Docket No: STN-50-470F

October 14, 1981
LD-81-070

Subject: CESSAR-F, Chapter 3, Round 1 Question Responses

SHELL (IN PLANE) 5 INC
TOTAL MOMENT

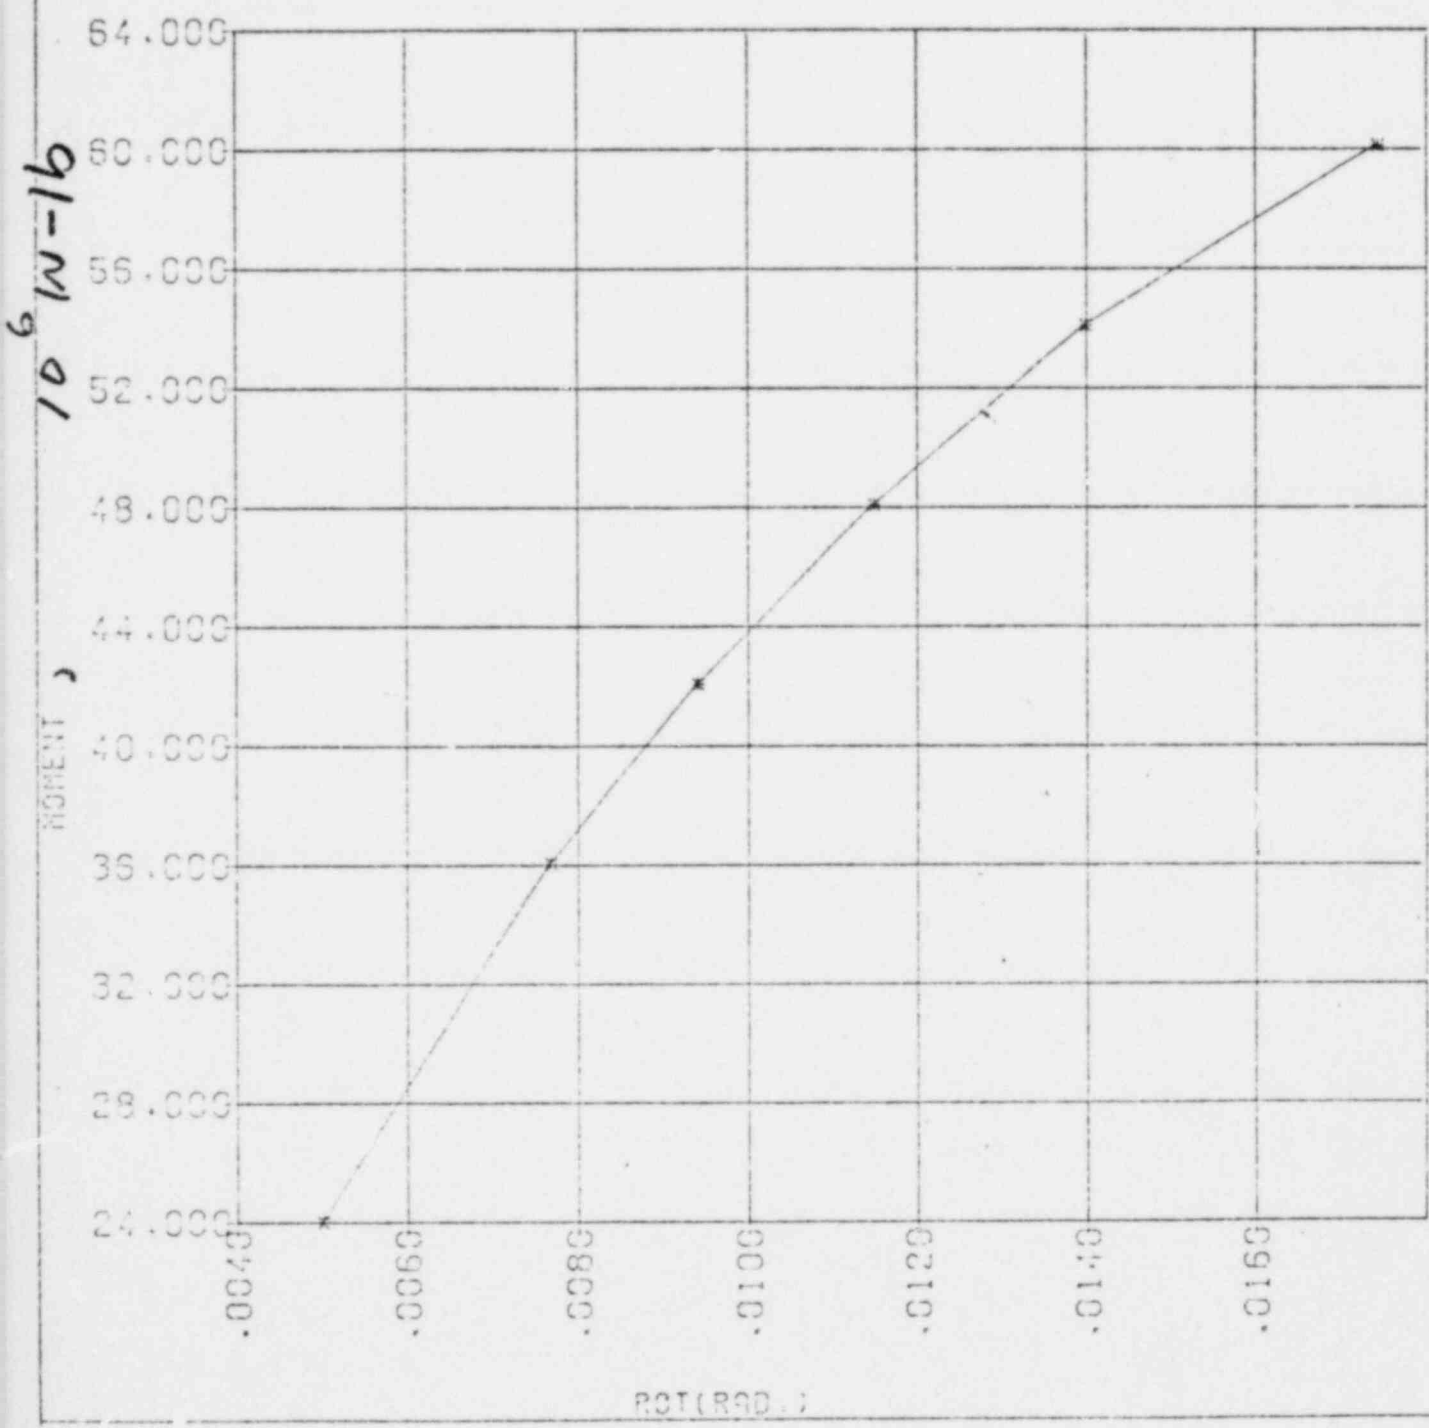
The attached stress strain curve for SA 516 Gr 70 at 650F was obtained by conventional testing in the CE Metallurgy Laboratory in Chattanooga. This curve was judged to be typical for this material by the Laboratory Staff. The MARC computer program uses a multi-linear representation of the curve as input for plasticity analysis. The input for the pipe ovalization analysis was based on straight lines between the circled points shown in the Figure. The maximum strain resulting from the analysis was 0.007 in/in.

SUCTION ELBOW TOTAL DISP. AT MIDDLE SECTION

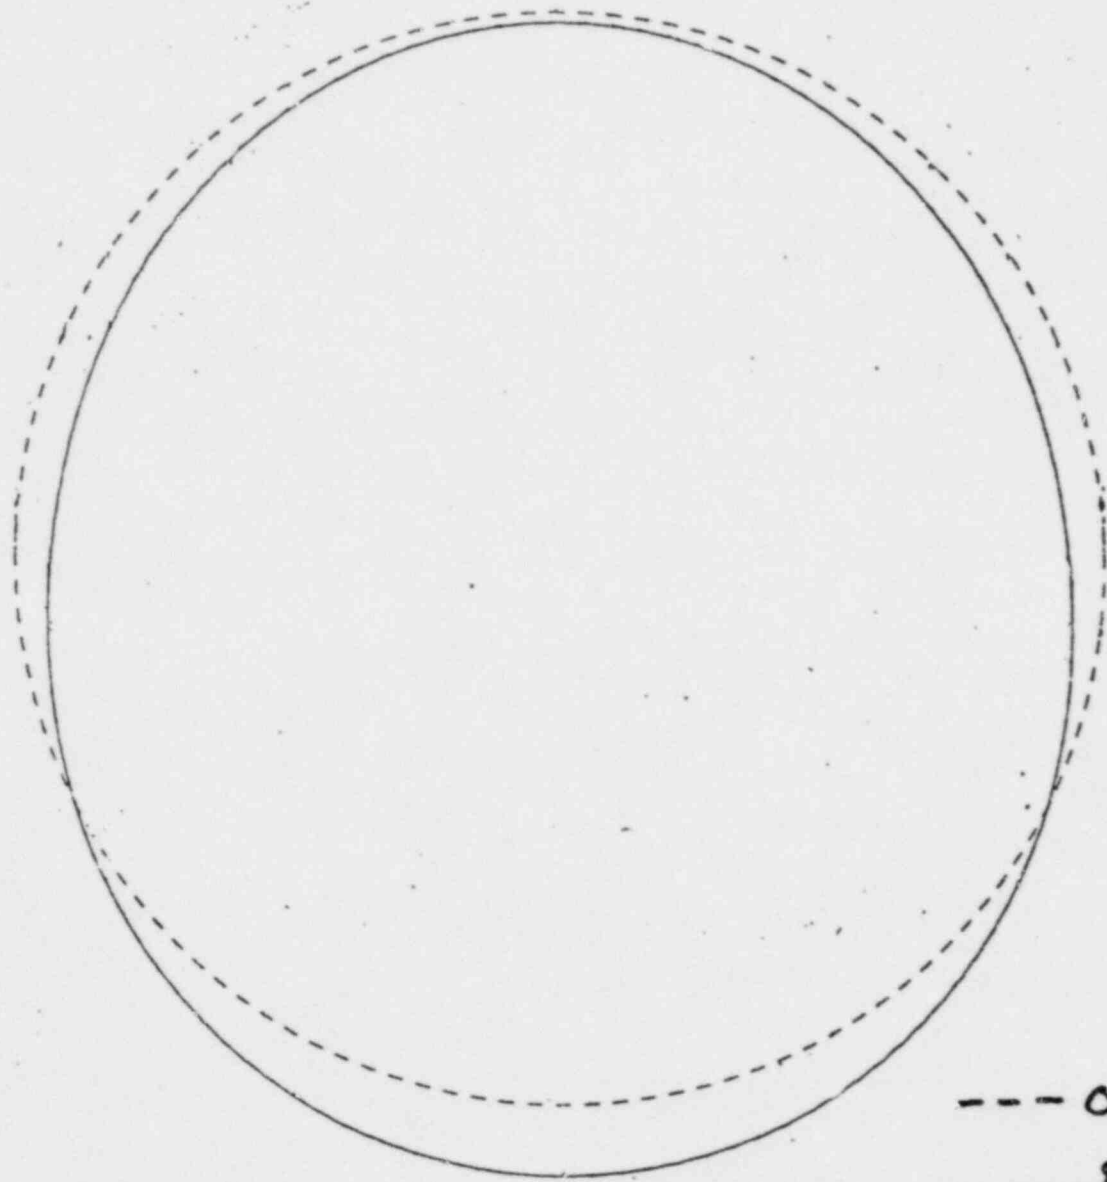
EFFECT OF MOMENT OF 60.2×10^6 IN-IB

FIGURE 3.9.3-1

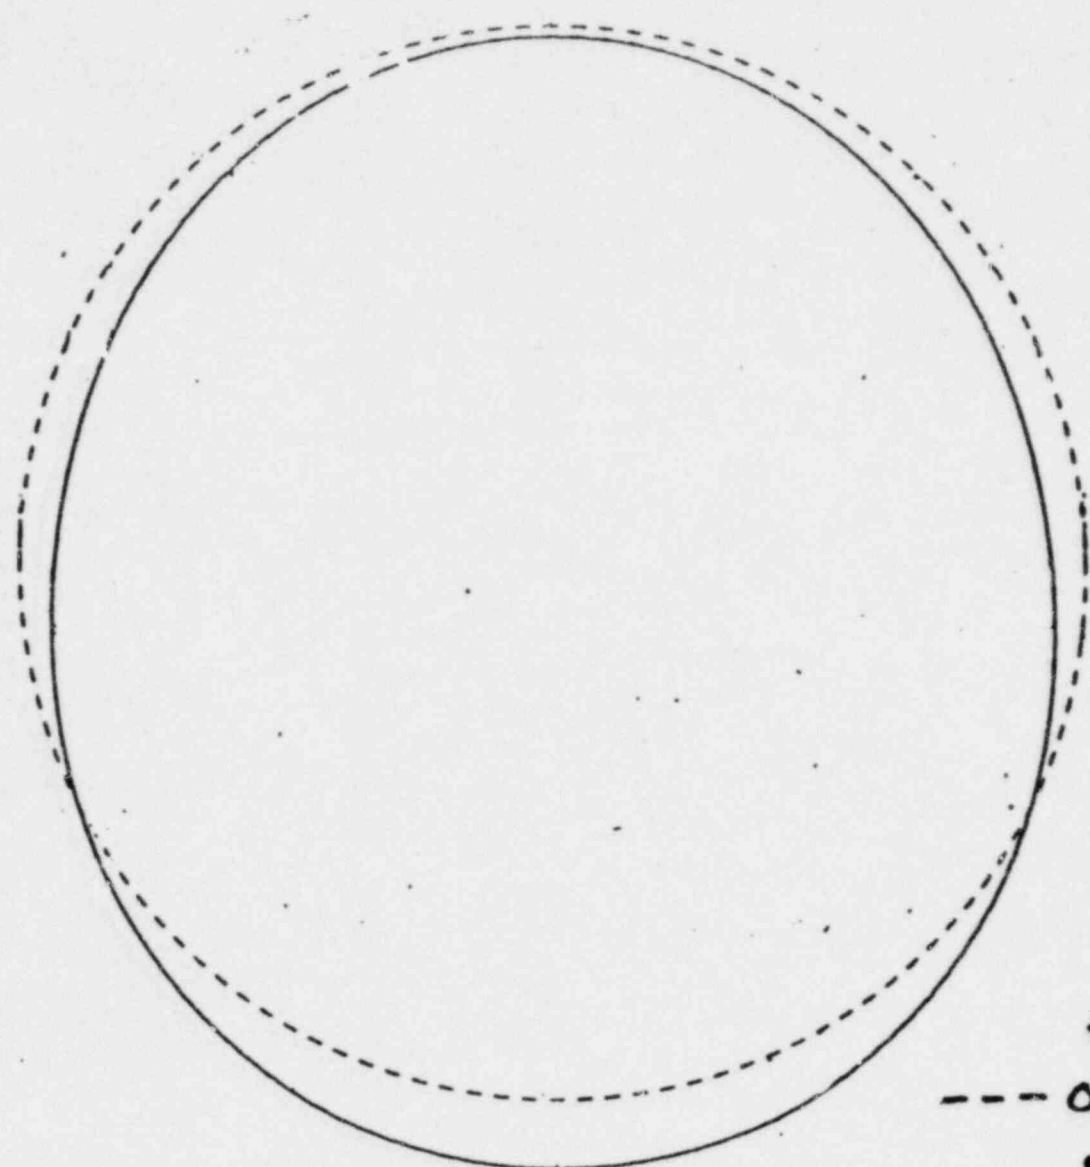
The deformation resulting from the application of a moment in excess of the maximum Level D moment, determined on an elastic basis, (56.7×10^6 in-lb) permitted by NB 3656 of Section III of the ASME Code has been calculated to demonstrate piping functionability following postulated pipe rupture. The calculated deformation is shown in Figure 3.9.3-1.
